**RESPONSE TO COMMENTS ON DRAFT NPDES PERMIT NO. NH0100196
TOWN OF NEWMARKET WASTEWATER TREATMENT PLANT
NEWMARKET, NEW HAMPSHIRE
NOVEMBER 15, 2012**

On October 5, 2011, the U.S. Environmental Protection Agency, Region 1 (“EPA”) and the New Hampshire Department of Environmental Services, Water Division (“NHDES”) published draft National Pollutant Discharge Elimination System (“NPDES”) permit number NH0100196 for public notice and comment. The draft permit proposed to reauthorize discharges of treated wastewater effluent from the Town of Newmarket, New Hampshire’s Wastewater Treatment Plant (“Facility”) to the Lamprey River. Comments were accepted until December 16, 2011.

Point Source versus Non-point Source Problem and Solutions

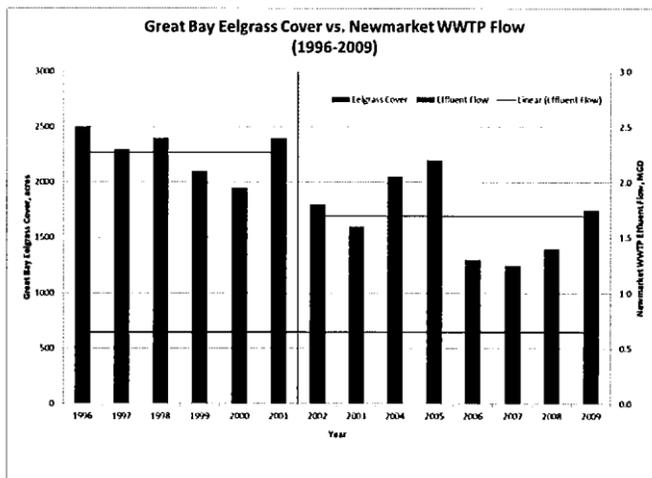
NHDES studies quantify the source of total nitrogen pollution into Great Bay as being 27% point source and 73% non-point source pollution in order to estimate the Total Maximum Daily Load allowed. Our WWTF has been discharging at a similar level from 1996 to 2011. This is the same time period where eelgrass was healthy initially and then declined in Great Bay. This is demonstrated in the following graph showing eelgrass cover in Great Bay versus the Newmarket WWTF flow.

Response #4: EPA does not dispute that the majority of the total nitrogen load into the Great Bay Estuary is from nonpoint sources, and it is for this reason (i.e., to provide NHDES and the Town with the framework and opportunity to pursue nonpoint source reductions) that EPA has opted for a nitrogen effluent limit of 3.0 mg/l rather than a more stringent limit equal to the numeric instream threshold that EPA has determined will attain and maintain applicable water quality criteria and fully protect designated uses. Please see *Reaffirmation of the Nitrogen Effluent Limitation of 3.0 mg/l* above.

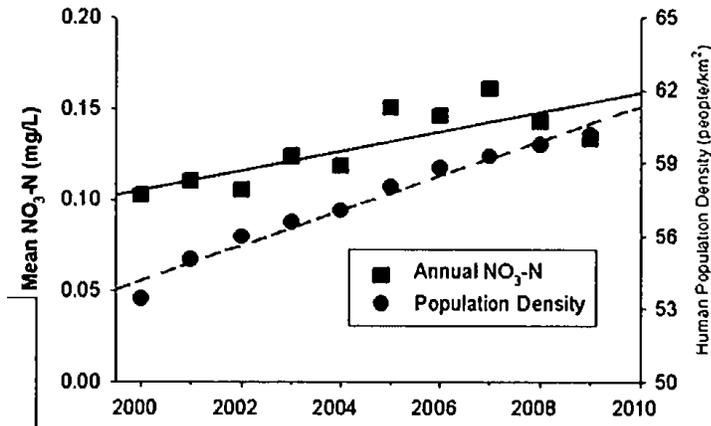
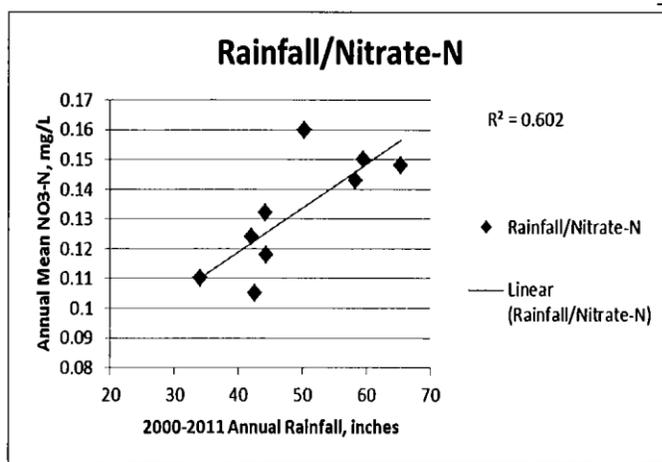
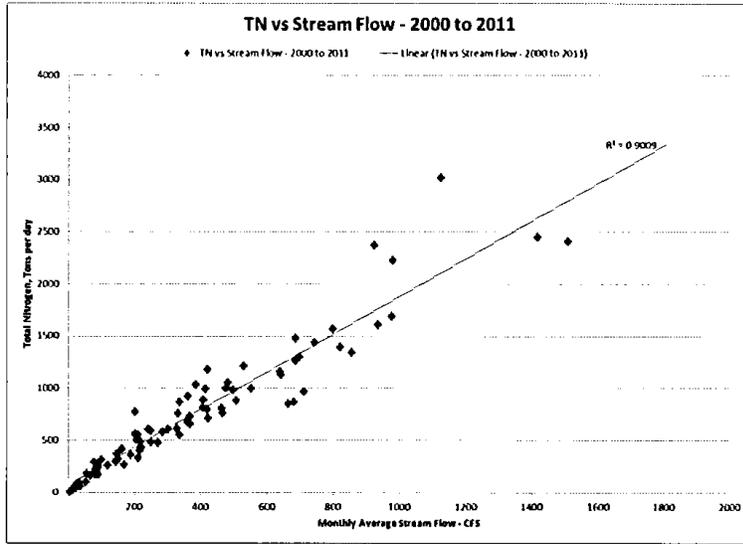
The first graph is the populations density in the Lamprey River Watershed and nitrate-nitrogen concentrations in the Lamprey river near Packers Falls from the May 10, 2011 SWA Science Symposium. This graph demonstrates the linear relationship between population increases and increases in nitrogen levels in the Lamprey River.

The second graph plots the rainfall in Durham, NH versus the nitrate-nitrogen levels in the Lamprey River near Packers Falls. This graph demonstrates the linear relationship between nitrogen levels and rainfall.

The third graph is information taken from the UNH sampling station LMP-73 for total nitrogen (particulate and total dissolved nitrogen) plotted as the monthly mean total nitrogen in tons per day versus river flow.

This location is at Packers Falls in Newmarket, upstream of the head of tide dam on Route 108 approximately 2 to 3 miles, in the fresh water section of the Lamprey River. This graph demonstrates that the total nitrogen in the river is directly related to the river flow and runoff rather than the point sources discharges.

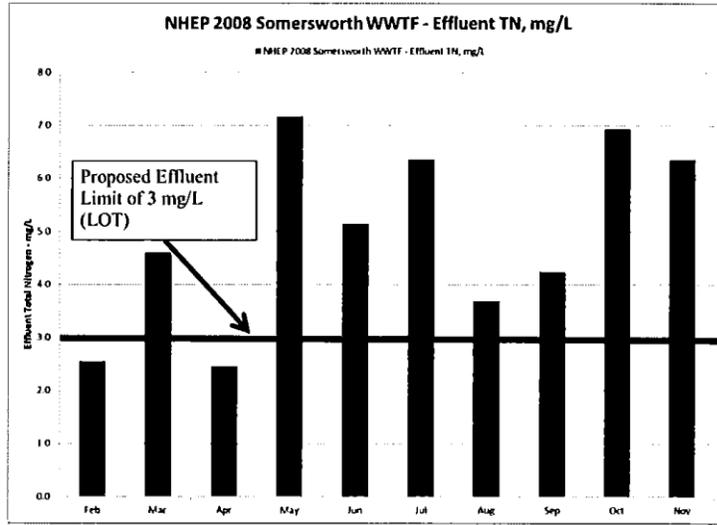
We question the capability of LOT treatment processes to meet the low monthly average total nitrogen value effectively because of the seasonal variation in the wastewater temperature. In the adjacent graph, we present a local WWTF near our Town that has a process capable of achieving limits of technology. This data is taken from the NHEP 2008 study of effluent nitrogen discharged from Great Bay wastewater treatment facilities.

The Somersworth, NH WWTF achieved a monthly average TN of 5 mg/l in 2008, suggesting LOT in our area of the country maybe higher than 3 mg/l.

Response #5: EPA disagrees that the imposition of an effluent limitation of 3 mg/l will eliminate the Town's ability to address nonpoint source pollution from septic systems or otherwise impede an adaptive management approach. Clean Water Act anti-backsliding prohibitions do not erect an absolute bar to subsequent relaxation of a permit's effluent limitations and, in this case, would not preclude the possibility of a permit modification to accommodate accepting additional flow from septic systems or other nonpoint sources of pollution. (The Permittee should be aware that an increase in plant flow may result in the increase in other pollutants and would need to comply with State of New Hampshire's antidegradation regulations at Env-Wq 1708.)

EPA does not agree with the Town's proposition that the LOT for New Hampshire is higher than 3 mg/l. The claim is based on the performance of one plant in a single year. The Somersworth WWTF employs a modified University of Cape Town process. This process was employed for biological removal of total phosphorus to meet the permit limit of 0.75 mg/l. This process is also able to remove nitrogen. According to Somersworth's engineering design firm, the plant is currently being optimized for phosphorus removal, not nitrogen removal. Steps could be taken at this facility to optimize the removal of nitrogen (Personal communication – Dan Arsenault, EPA with Steve Clifton of Underwood Engineers, 8/10/12).

Extreme Wastewater Temperatures Prohibit Limit of Technology Limits

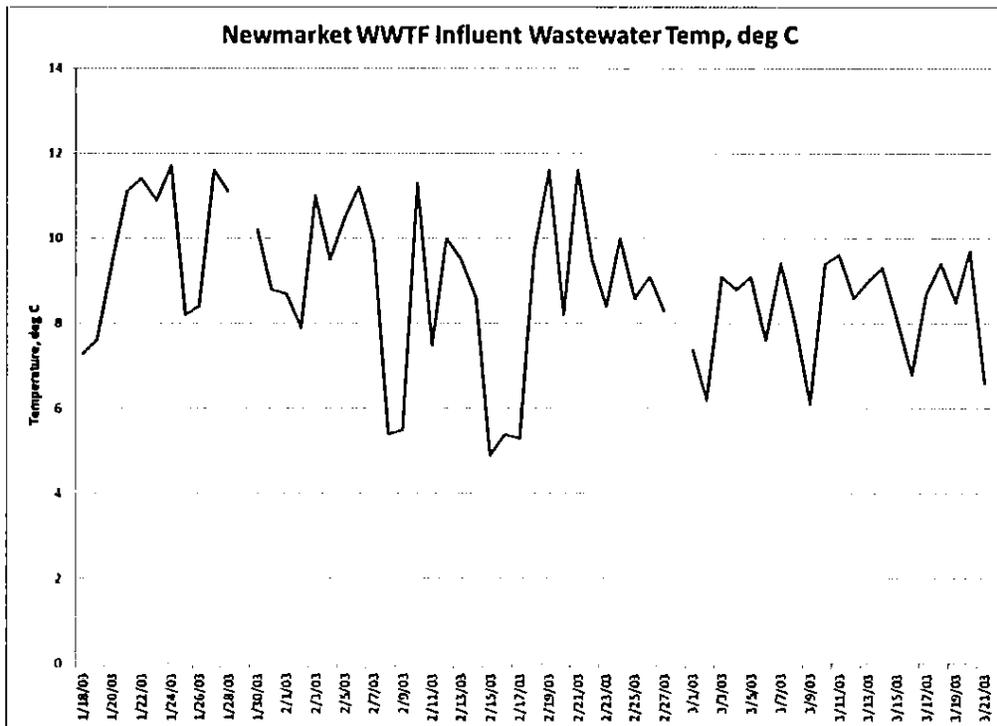
EPA's Reference Document addresses the impact of wastewater temperature on nitrogen removal. Most of the nitrogen removal data cited by EPA came from southern climate plants with wastewater temperatures in the range of 20 degrees Celsius. Temperature has a very significant impact on nitrogen removal efficiency and Newmarket's winter/spring time temperatures through April are very cold due to the climate and the magnitude of infiltration/inflow problems. As shown in the adjacent graph, Newmarket's influent wastewater temperature is typically 8 to 10 degrees Celsius in the winter and can get as low as 5 degrees Celsius. At temperatures as low as this, achieving a 3 or 4 mg/l TN limit is not practical. For this reason, the TN limit should begin in May and not April. This is consistent with the precedent set in Cranston and Woonsocket, RI based on Narragansett Bay water quality protection. With warmer temperatures there, one would assume that Narragansett Bay has an earlier start to the growing season than Great Bay.

Response #9: The proposed permit limit of 3.0 mg/l is based on the need to maximize point source reductions, while at the same time providing a framework for addressing other sources of nitrogen in the watershed. The limit of 3.0 mg/l accomplishes the goal of maximizing point source reductions within the capabilities of current technology.

Figure NUT3-1: Long-term trends for chlorophyll-a concentrations measured monthly at Adams Point in Great Bay

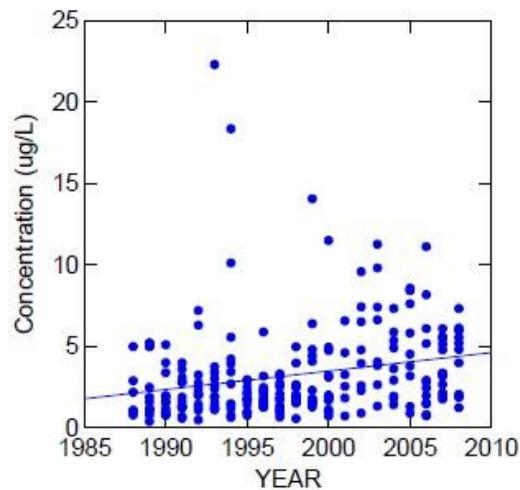
EPA disagrees with the Coalition's contention, based on selective use of data, that chlorophyll-a concentrations in Great Bay did not increase between 1993 and 2000. The average annual concentrations shown in Exhibit 8 masks the trend that is apparent when the full dataset is considered. The PREP 2009 Environmental Indicators Report Figure NUT3-1, reproduced below, shows a clear increasing trend between 1988 and 2008, with very obvious peaks in maximum chlorophyll-a in 1993 and 1994, just prior to the documented onset of eelgrass decline in 1996. (PREP, 2009b) The commenter's assertion that algal growth could not have been the cause of eelgrass decline is therefore incorrect.

EPA notes that the same figure the commenter cites as showing that algal levels increased by only 1 ug/l from 2001 to 2008 (a box and whisker plot) also shows that the 75th percentile concentrations increase by over 3 ug/l, or more than double, in the same period. Indeed, this is consistent with the commenter's own Exhibit 8, which shows annual averages ranging from approximately 2.4 to 6 ug/l in 2001 to 2008, compared to annual averages consistently below 2 ug/l prior to 2001. However, EPA notes that more recent data do not indicate a statistically significant increasing trend in chlorophyll-a through 2011 in Great Bay proper (PREP, 2012), in

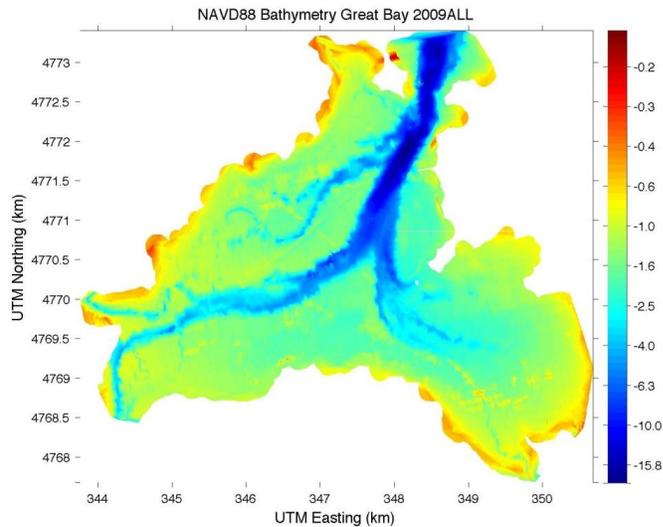
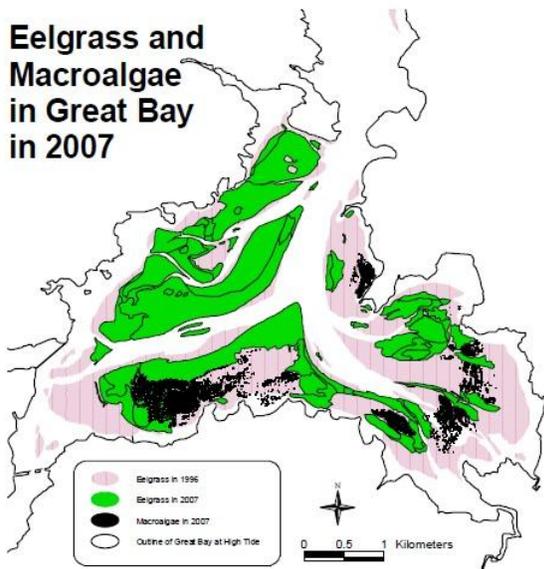
It is unclear how the commenter interprets Figure HAB2-2 of PREP (2009b) as indicating that "higher losses appear to have occurred in shallower environments where the most light is available and eelgrass are healthiest in the deeper waters." Figure HAB2-2 shows neither the bathymetry of Great Bay nor prior eelgrass conditions and therefore is ill-suited for assessing loss of eelgrass in relation to depth. Comparison of a bathymetry map with the eelgrass loss map in the NHDES numeric nutrient criteria does not support the commenter's assertion. Eelgrass losses appear to be less severe in the -1.0 to -1.6m depth range (green on the bathymetry; see area west of main channel) as compared to the areas closer to the -2.5 m depth range (blue on the bathymetry; see area east of main channel and south of channel split), although with losses in shallower areas where macroalgae has proliferated and/or close to the main tributary nitrogen sources. EPA therefore finds no merit in the comment's conclusory assertions concerning the relationship between depth and eelgrass losses. EPA agrees that macroalgae and shoreline conditions may also impact eelgrass decline, but notes that this does not disprove the established relationship between eelgrass and transparency.

Source: *Numeric Nutrient Criteria for the Great Bay Estuary* (NHDES, 2009a). More recent data show the same pattern (PREP, 2012, Figure HAB2-3).
